Object: Creation variant "Fast 5260"

Reference F@st 5260CV	Variant Fast 5260
FCC ID : VW3FAST5260CV	FCC ID : VW3FAST5260

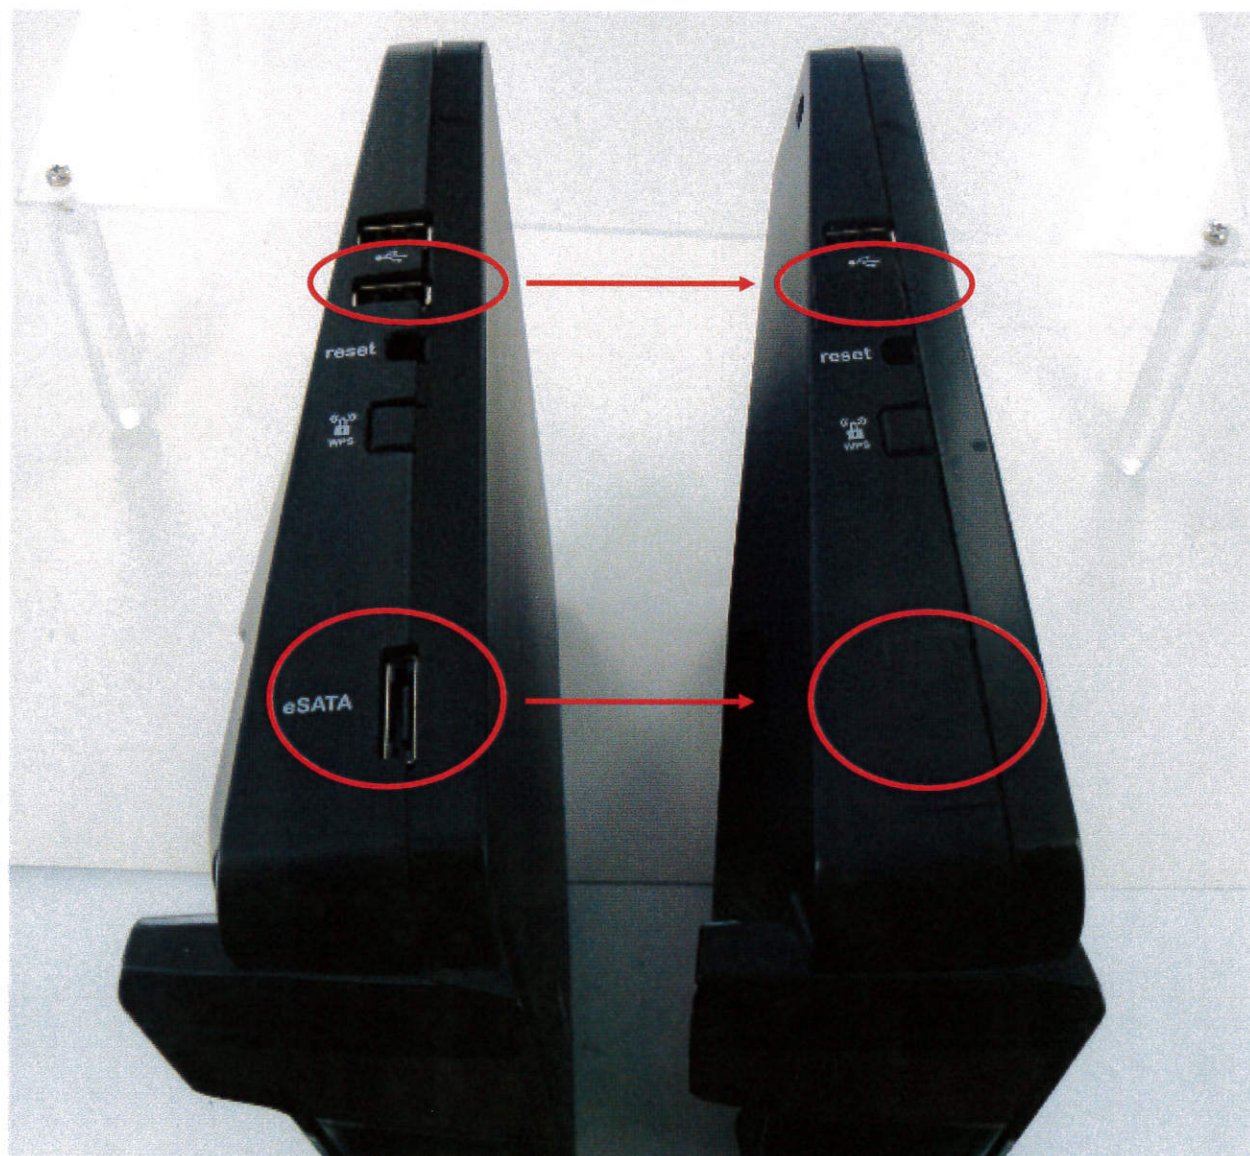
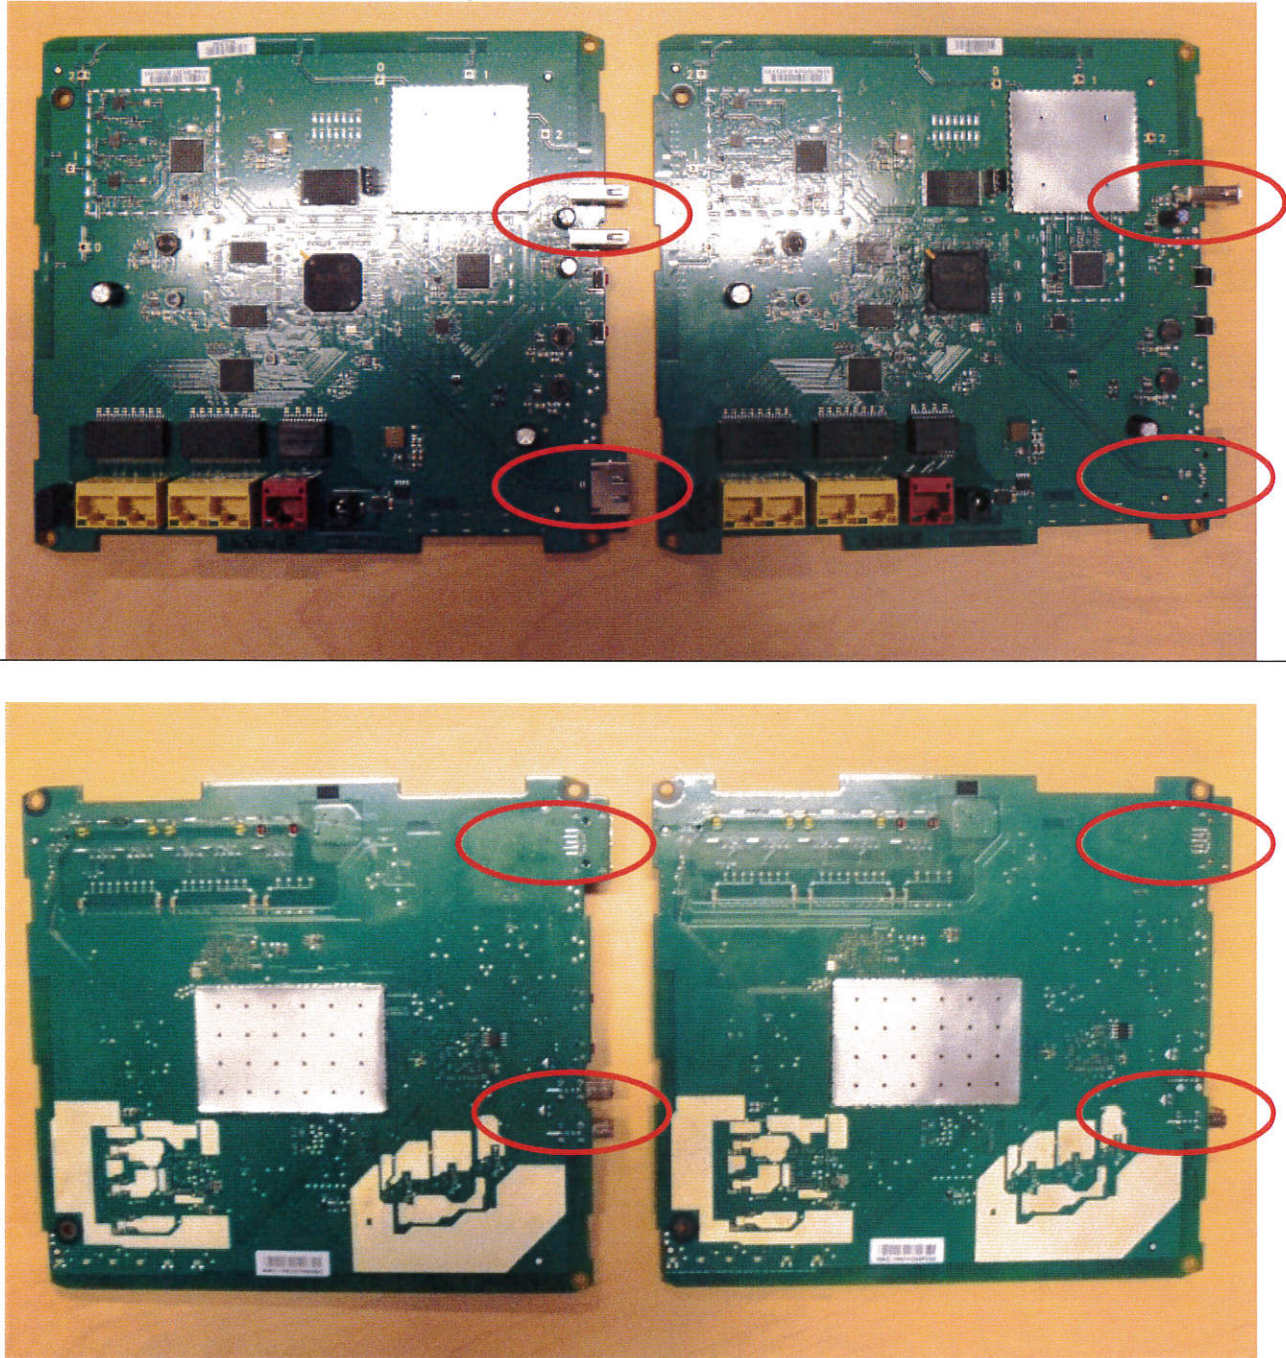
New plastic box without openings for e-SATA and one USB connectors

Variant Fast 5260

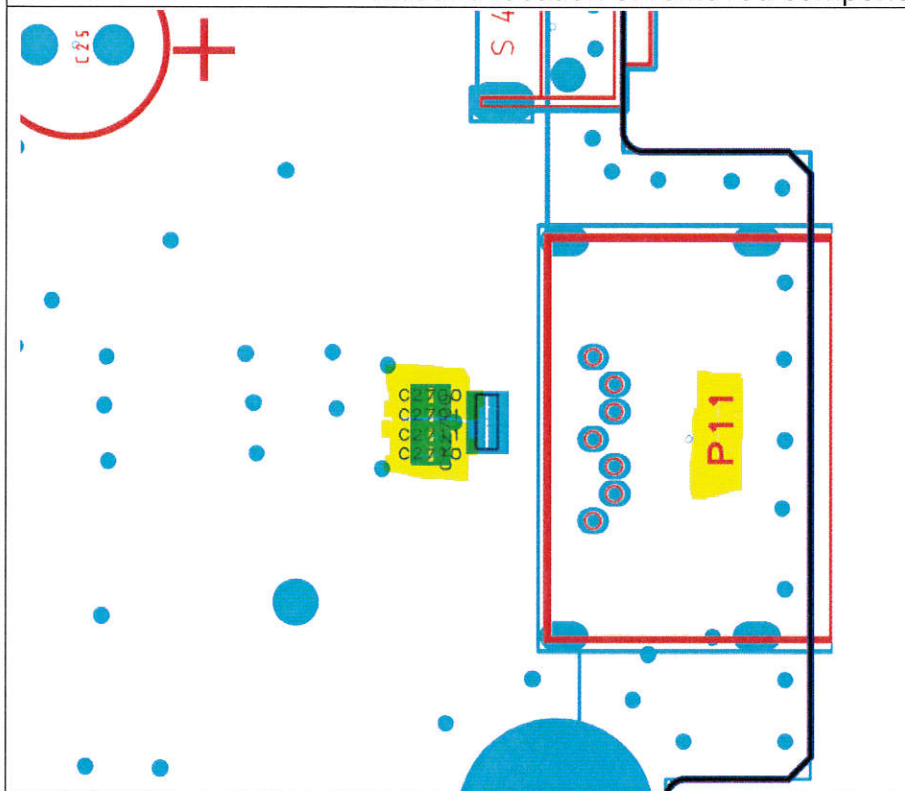
Reference F@st 5260CV FCC ID : VW3FAST5260CV	Variant Fast 5260 FCC ID : VW3FAST5260
Removal of connectors and components for e-SATA and one USB interfaces

List and location of removed components

Components in yellow color are removed

P9
P11
C1041
C1043
C2700
C2701
C2710
C2711
L1040
R1001
R1003
R1040
MX1040
